Memorandum

RE: **P.Z. 02-2015 Falling Leaves Estates II (1925**

Planning Commission Vote Report

Petition: **P.Z. 02-2015 Falling Leaves Estates II (1925 & 1921 Wilson Ave)**

Figure 4 – Common Ground & Common Open Space

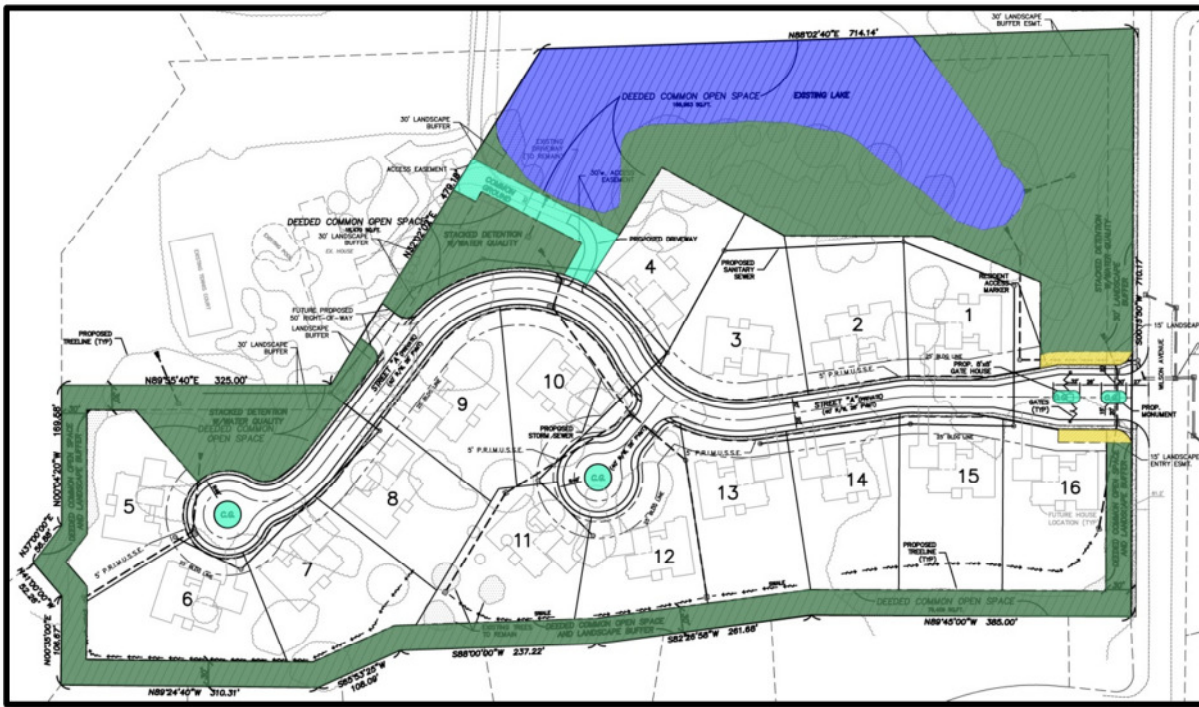
To address the Planning Commission concern about the proximity of Lot 16 to the entrance gate, the Petitioner will provide an additional 15 foot Landscape Easement, located on each side of the private entrance. This area will contain landscaping and will provide a buffer, especially

for Lot 16, from the gated entrance. The exact location and type of landscaping will be determined during Site Development Plan review, if this zoning map amendment request is approved. (This easement area is highlighted in yellow on Figure 4 below).

- As discussed above, the Petitioner redesigned the Preliminary Plan to remove the lot proposed near the northeast corner of the site. This, in turn with the combination of proposed density, would allow for 38% of the site (6.52 acres) being reserved as Common Open Space – this includes the existing lake on the site. The previous Preliminary Plan only had 34% Common Open Space.

An additional 0.23 acres (1%) of Common Ground is proposed and is located near the lake, near the entrance, as well as landscape islands within cul-de-sacs. Figure 4, below, highlights the areas dedicated as Common Open Space (darker green and blue for the lake) and Common Ground (lighter green).
